FIGURE 7.6-1 NEUTRON MONITORING SYSTEM IED SH 1 OF 4

FIGURE 7.6-5 PROCESS RADIATION MONITORING SYSTEM IED (Sheet 1 of 11)

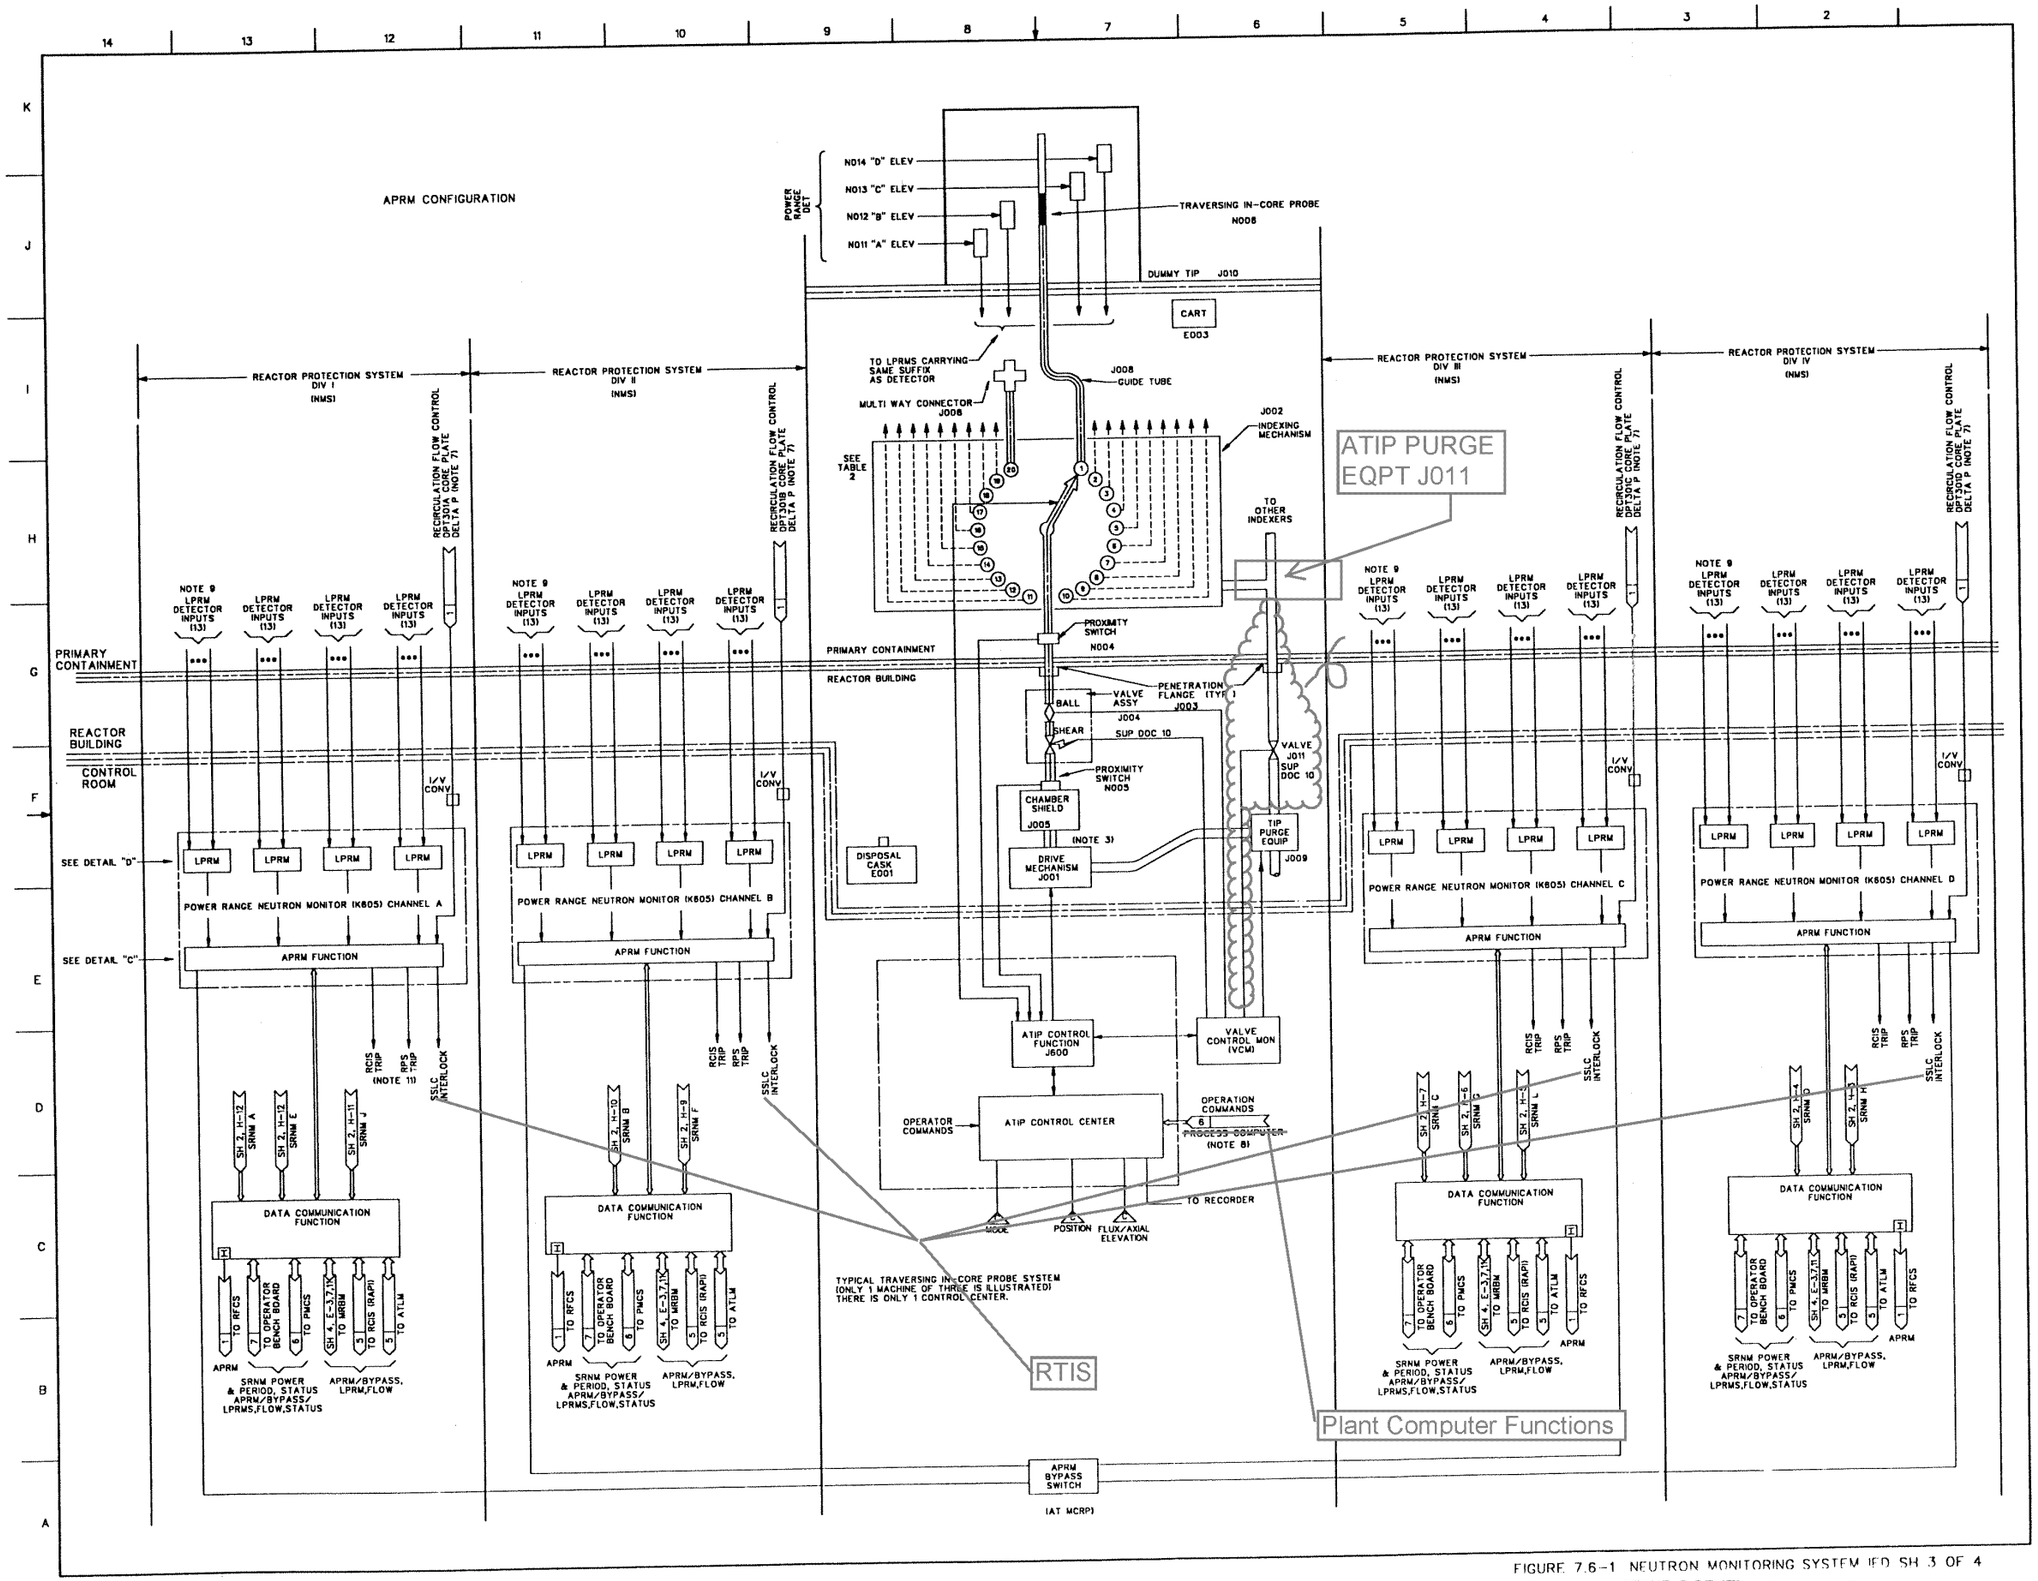
120V AC DIVISIONAL UPS BUS A	B	C	D
DIVISION	I	II	III	IV
SRNM CH'S	A,E,J	B,F	C,G,L	D,H
APRM CH'S	A	B	C	D
	120V AC NON-DIVISIONAL UPS A	B	C	D
MRBM CH'S	A	B		
SRNM RECORDERS	A,E,J	B,F	C,G,L	D,H
APRM RECORDERS	A	B	C	D
MRBM RECORDERS	A	B	A	B
460V, 3 Ø 3KVA:	ATIP DRIVE MECHANISMS			
~~120V AC:~~	~~ATIP INSTR. PANEL~~

8. COMMAND AND CONTROL SIGNALS BETWEEN THE ~~PROCESS COMPUTER~~ AND THE ATIP OTHER THAN ATIP MEASURED DATA ARE TRANSMITTED THROUGH THIS DATA ENTRY POINT.

9. IN CASE OF USING ~~MULTIPLEXING UNITS OR SUB-MUX UNITS~~, DETECTORS SIGNALS ARE ~~DISTRIBUTED~~ TO FOUR MULTIPLEXER UNITS, IN ~~EACH DIVISION~~ ACCORDING TO TABLE 1 ARRANGEMENT. THE ~~MULTIPLEXER~~ UNIT ASSIGNMENT ONLY DEPENDS ON LPRM STRING LOCATION AND ARE IDENTICAL FOR ALL FOUR DIVISIONS.

11. FOR DETAIL TRIP SIGNAL FUNCTIONAL INTERFACES WITH RCIS & RPS, REFER TO SUPPL DOC 8. THERE SHOULD BE A SEPARATE RCIS AND RPS TRIP LOGIC FUNCTION INDEPENDENT OF EACH INDIVIDUAL SRNM CHANNEL IN THE DIVISION. THE ~~OSLC~~ INTERLOCK SIGNAL IS THE "ATWS PERMISSIVE" SIGNAL.

13. THE SIGNAL TRANSMISSION PATH CAN BE EITHER THROUGH ~~MULTIPLEXING OR~~ THROUGH DEDICATED CONDUCTORS.
14. TRIP SIGNALS FROM THE NMS TO THE PMCS SHALL BE TRANSMITTED VIA DEDICATED CONDUCTORS (E.G. METAL CABLE WITH PROPER ISOLATION) TO AVOID UNNECESSARY TIME DELAY FOR TRIP SEQUENCE RECORDING.

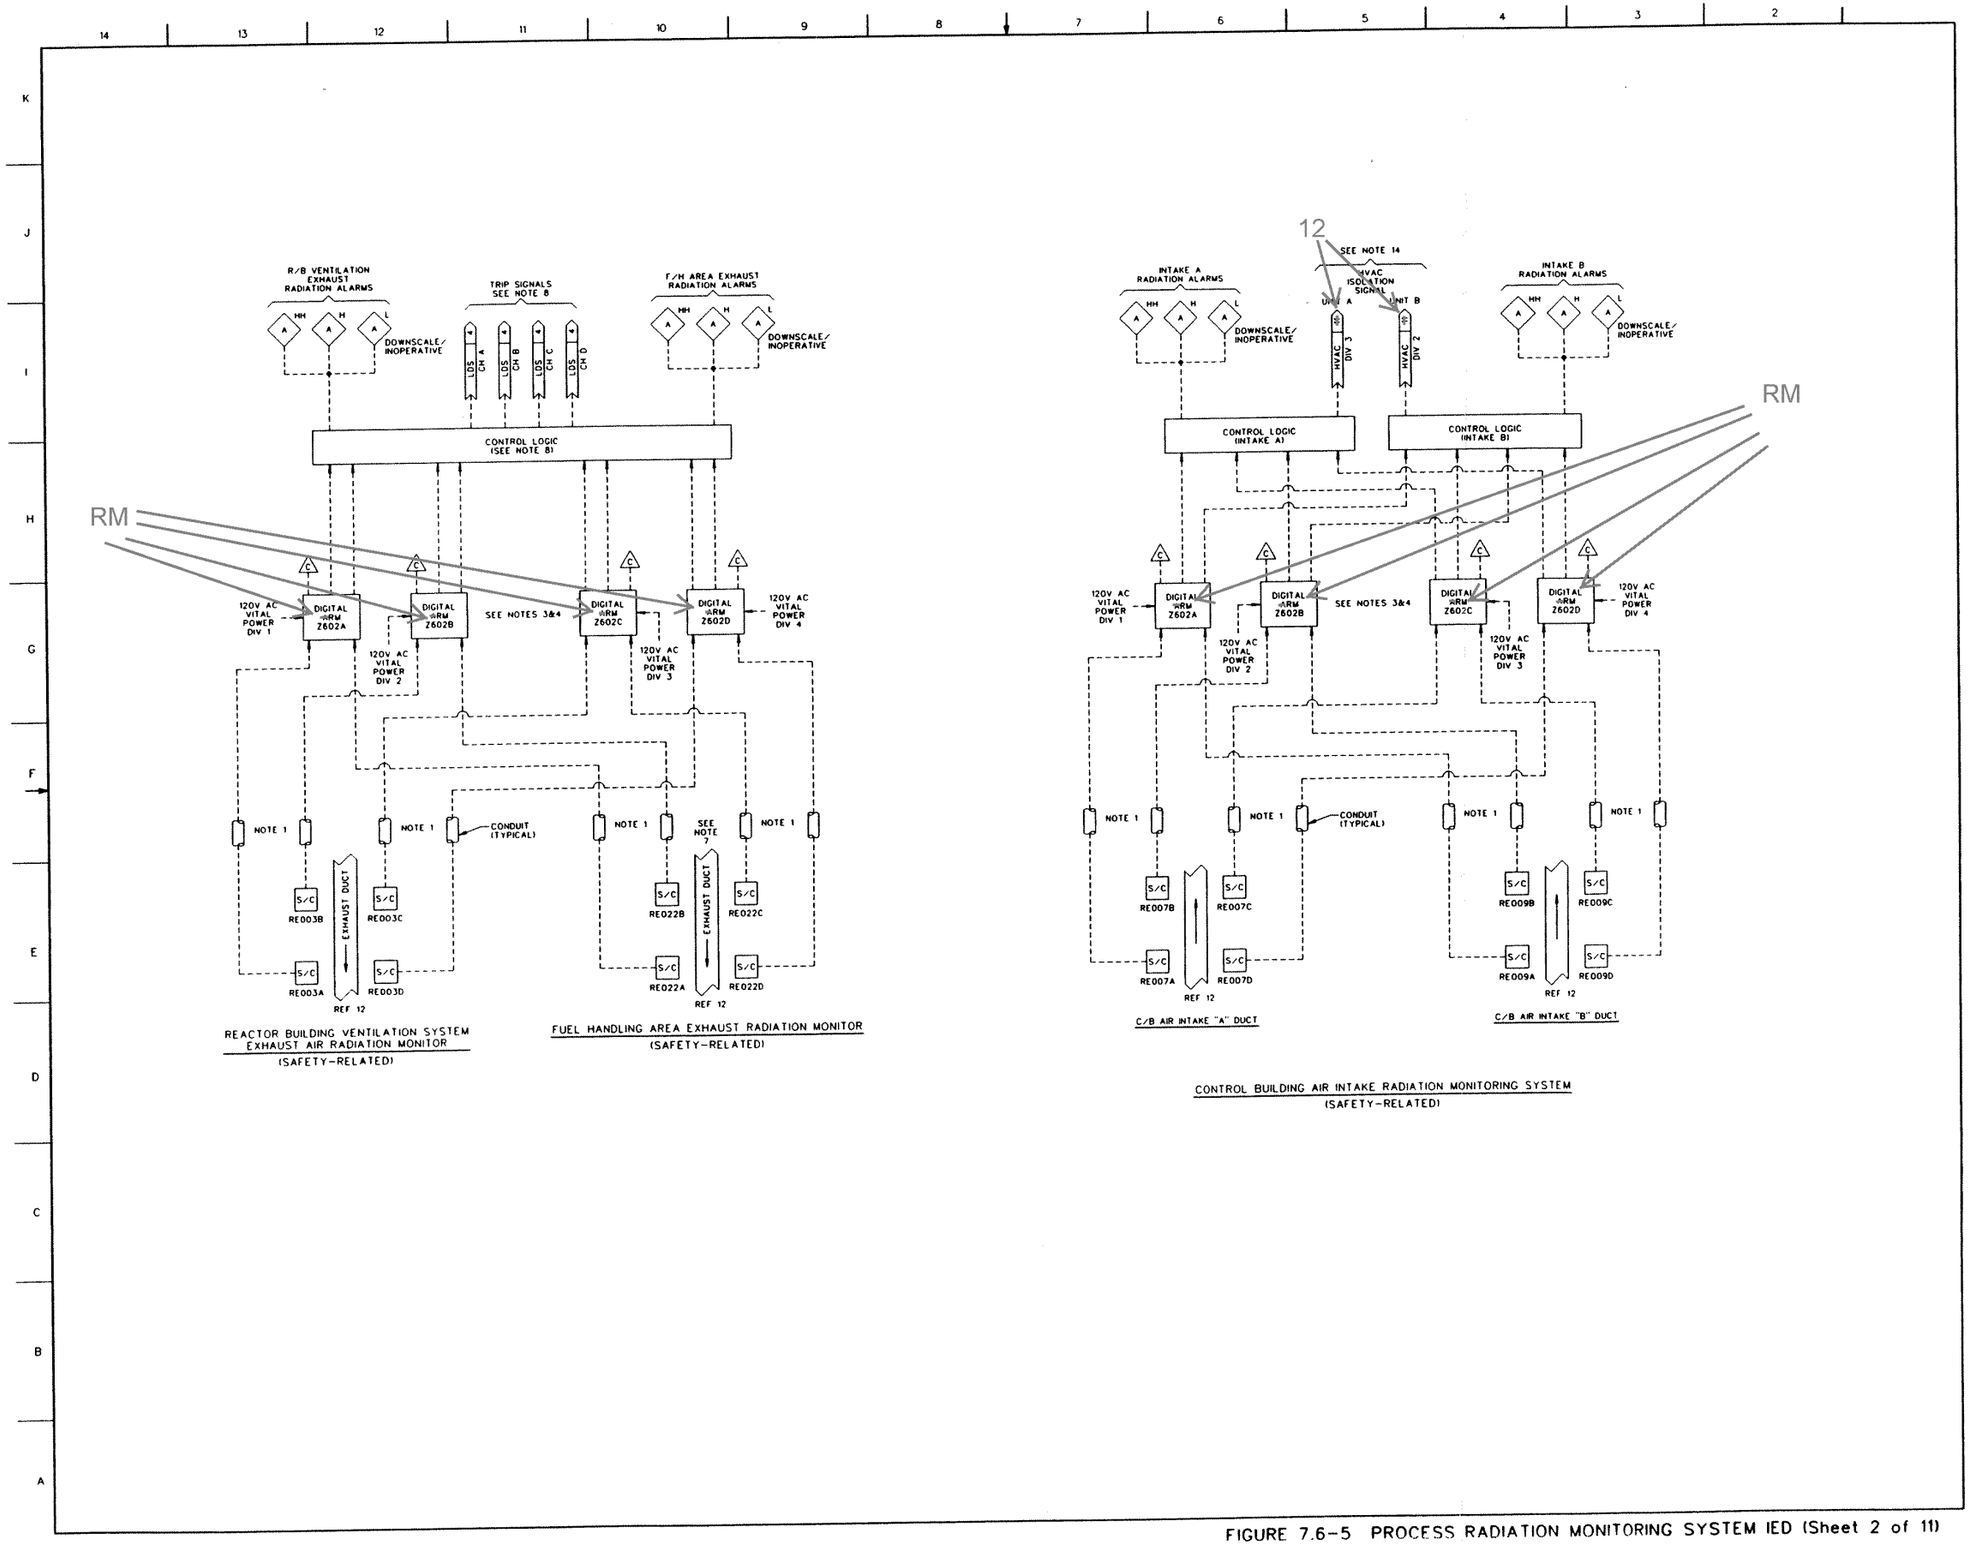
~~ARM - AREA RADIATION MONITOR~~
~~LCRM - DIGITAL LOG COUNT RATE METER~~
~~GM-B - BETA SENSITIVE GM DETECTOR~~
~~GSIC - GAMMA SENSITIVE ION CHAMBER~~
~~SYC - DIGITAL GAMMA SENSITIVE GM DETECTOR~~
~~LRM - LOG RADIATION MONITOR~~
USC - ULTRASONIC CLEANING
--> - SERIAL MULTIPLEXED SIGNALS

3. FIBER OPTIC CABLES MAY BE USED IN THE DESIGN OF THIS SYSTEM PROVIDED THESE CABLES CONFORM TO THE REQUIREMENTS STIPULATED IN REF DOC(S) 1&2.
4. EACH ~~DIGITAL ARM~~ Z602A,B,C,D ~~& Z603~~ AND ~~LCRM~~ Z701 TO Z704 CAN ACCOMODATE MULTIPLE CHANNELS. THESE MONITORS ARE SHARED WITH THE OTHER SUBSYSTEMS AS INDICATED IN THIS DRAWING.

A. ~~REACTOR SCRAM~~
   ~~B. CLOSURE OF THE MSIV AND MS DRAIN LINE MV VSS~~
   ~~B.~~ C. SHUTDOWN OF THE MAIN CONDENSER MECHANICAL VACUUM PUMP AND CLOSURE OF THE EXIT LINE ISOLATION VALVE

Move text up to align with 'A'

9. THE OFF-GAS SAMPLE CHAMBER SHALL BE MOUNTED VERTICALLY WITH ITS PIPING SLOPED AWAY FROM THE CHAMBER TO PERMIT THE CONDENSATE TO DRAIN TO THE PROCESS LINE. A DRAIN SHALL BE PROVIDED AT THE BOTTOM OF THE SAMPLE CHAMBER
10. EACH RADIATION MONITOR SHALL PROVIDE TRIP SIGNALS TO THE OFF-GAS SYSTEM TO PERFORM THE FOLLOWING FUNCTIONS:
    A. BASED ON ONE-OUT-TWO LOGIC SIGNAL, THE RADIATION HIGH-~~HIGH~~ TRIP SIGNAL FROM EITHER MONITOR SHALL ~~INITIATE VALVE ALIGNMENT OF THE OFF-GAS SYSTEM TO FORCE THE GASEOUS EFFLUENTS THROUGH THE CHARCOAL VAULT FOR TREATMENT PRIOR TO RELEASE TO THE STACK~~

close the Offgas bypass valve

15. ~~TEE SHALL BE UNION TEE SWAGELOCK TYPE SS-1610-3~~
16. ~~THE SAMPLE LINE SHALL BE 25.4mm X 1.47mm WALL THICKNESS SEAMLESS STAINLESS STEEL TUBING. THE TUBING MINIMUM BEND RADIUS SHALL BE 508mm. THE TUBING LENGTH SHALL BE JOINED WITH SWAGELOCK TYPE SS-1610-6 UNIONS. THE TUBING SHALL SLOPE SO THAT THE CONDENSATE WILL RUN TO DRAIN TEE.~~

18. HEATER AND CONDENSATE DRAIN WITH TRAP TO BE SIZED SO THAT TEMPERATURE OF SAMPLE STREAM IS KEPT ABOVE DEW POINT.
19. CONTROL OF THE CHECK SOURCE CAN BE INTEGRATED INTO THE ~~DIGITAL~~ LCRM AS PART OF THE MONITOR

20. ~~THE RADIATION HIGH-HIGH TRIP OR THE DOWNSCALE/INOPERATIVE TRIP SHALL TERMINATE OPERATION OF THE VENTILATION FANS.~~

FIGURE 7.6-11 SUPPRESSION POOL TEMPERATURE MONITORING SYSTEM (1 SHEET OF 3)

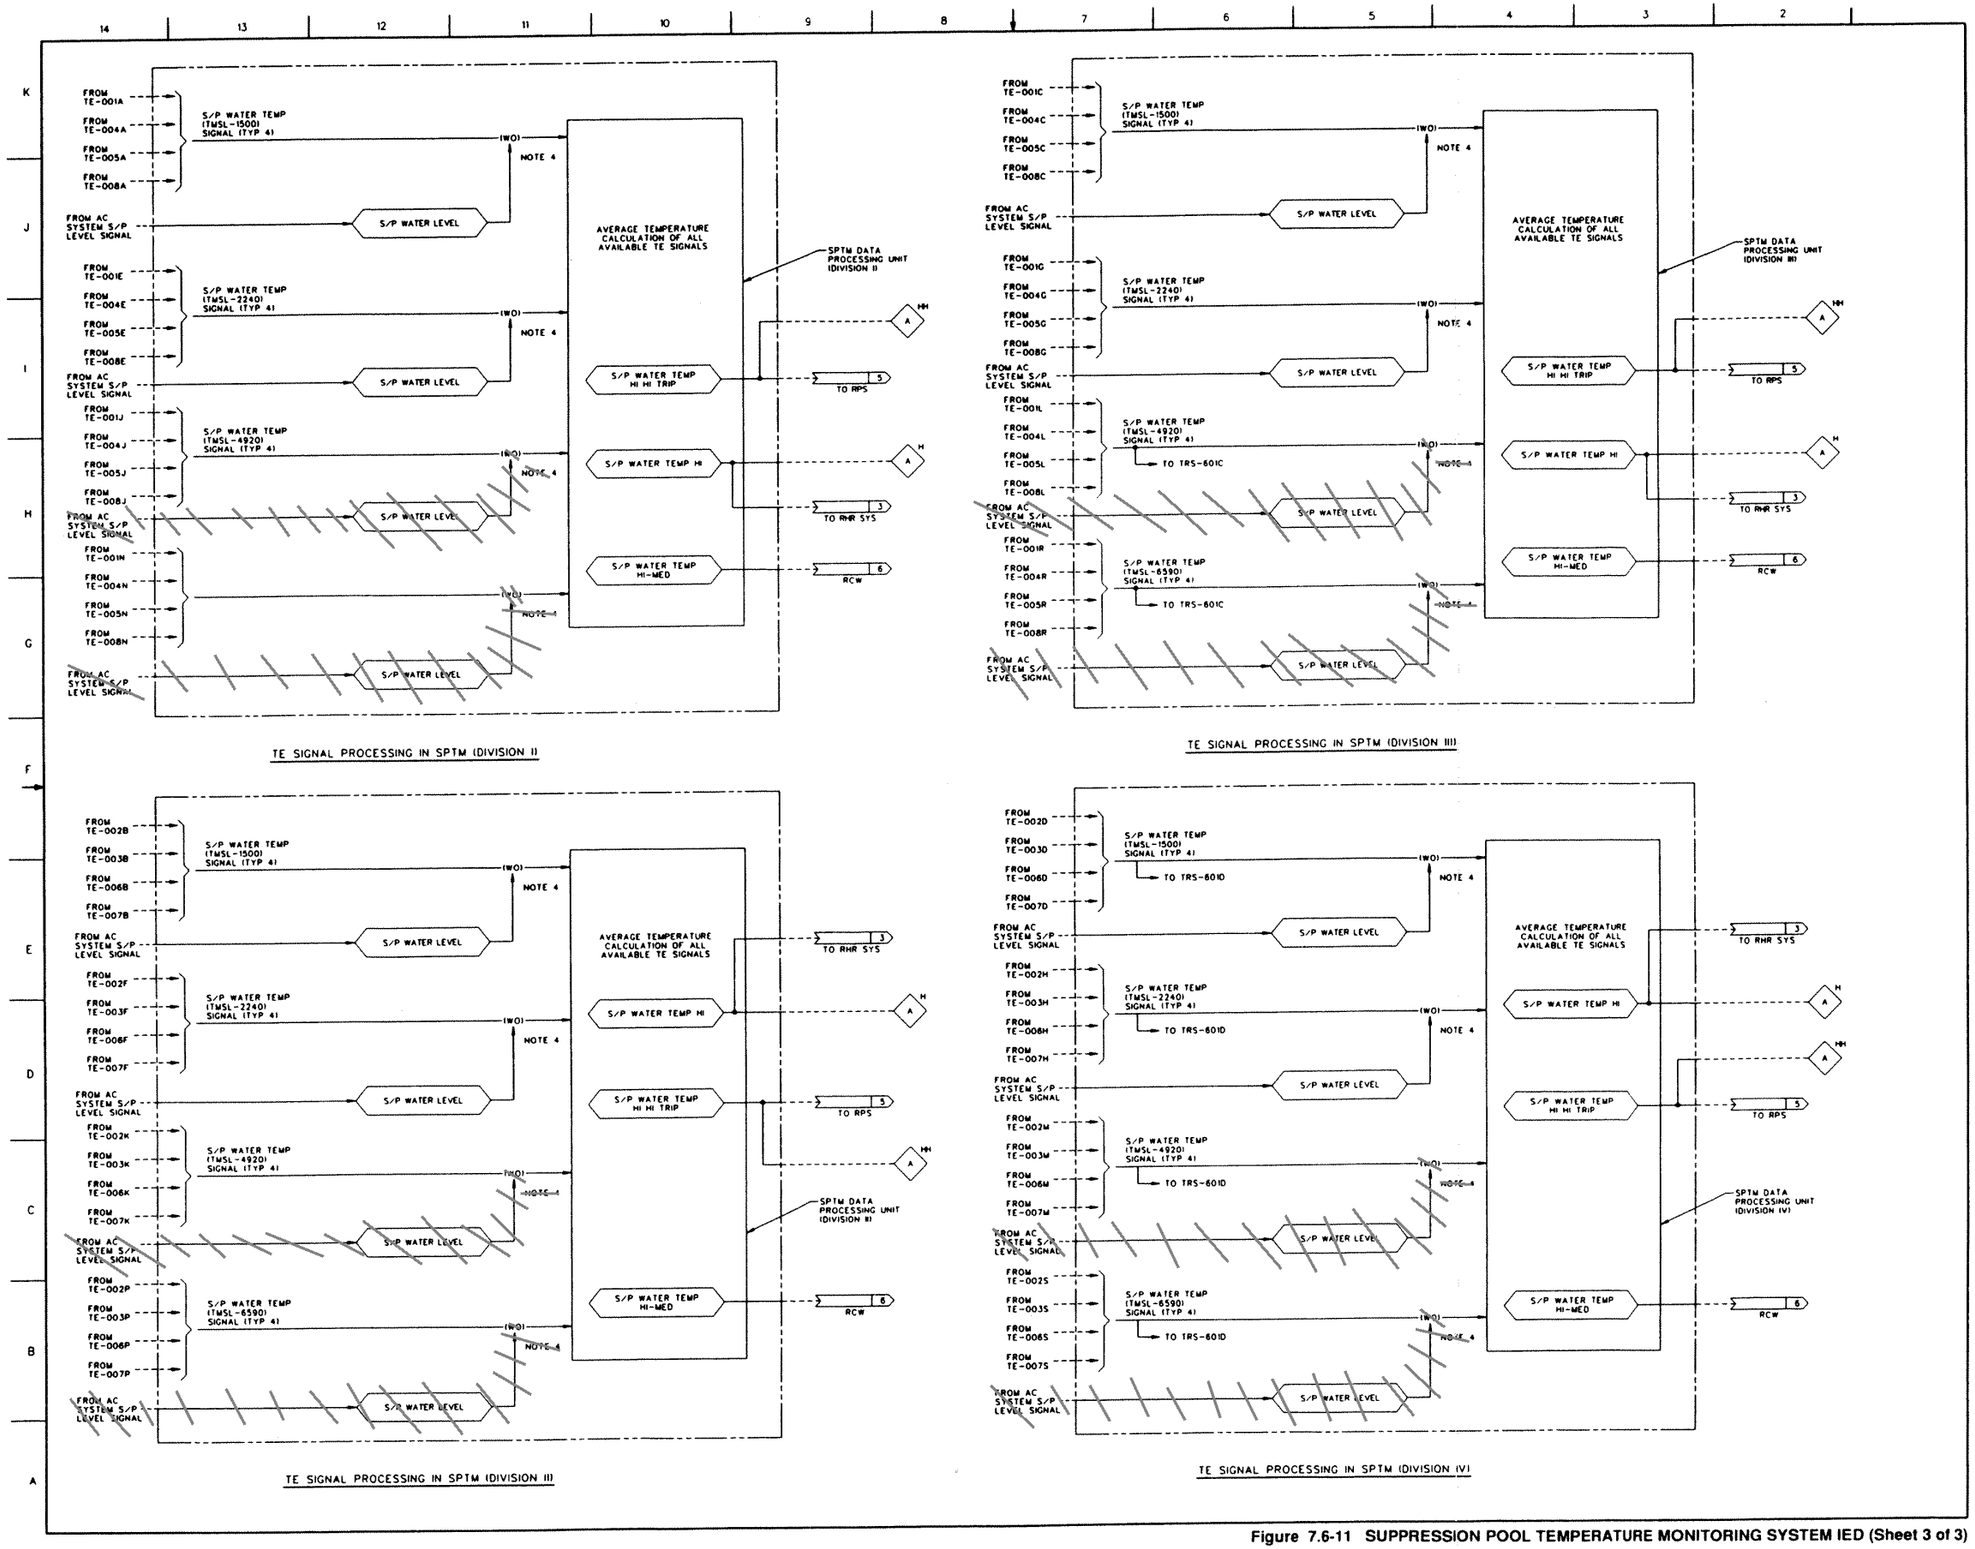
1. DIVISION I AND DIVISION III AND DIVISION II AND DIVISION IV TEMPERATURE SENSORS AT EACH LOCATION SHALL BE SEPARATED BY 150 300 MM (6-12 INCHES)
2. TYPICAL OF DIVISION I AND DIVISION II SENSORS AT AZIMUTHAL LOCATIONS 16° AND 61°. DIVISION III AND DIVISION IV SENSORS ARE NOT SHOWN
3. BULK AVERAGE TEMPERATURE ALARM
4. SIGNALS FROM TE WHICH ARE LOCATED AT THE SAME LEVEL SHALL BE OMITTED FROM AVERAGE TEMPERATURE CALCULATION, WHEN S/P WATER LEVEL DECREASE BELOW SENSOR LEVEL
5. MIDDLE QUENCHER LEVEL
6. TWSL = TYPICAL MEAN SFA LEVEL
7. NUMBER ARE IN MILIMETER EXCEPT (.) WHICH ARE IN INCHES
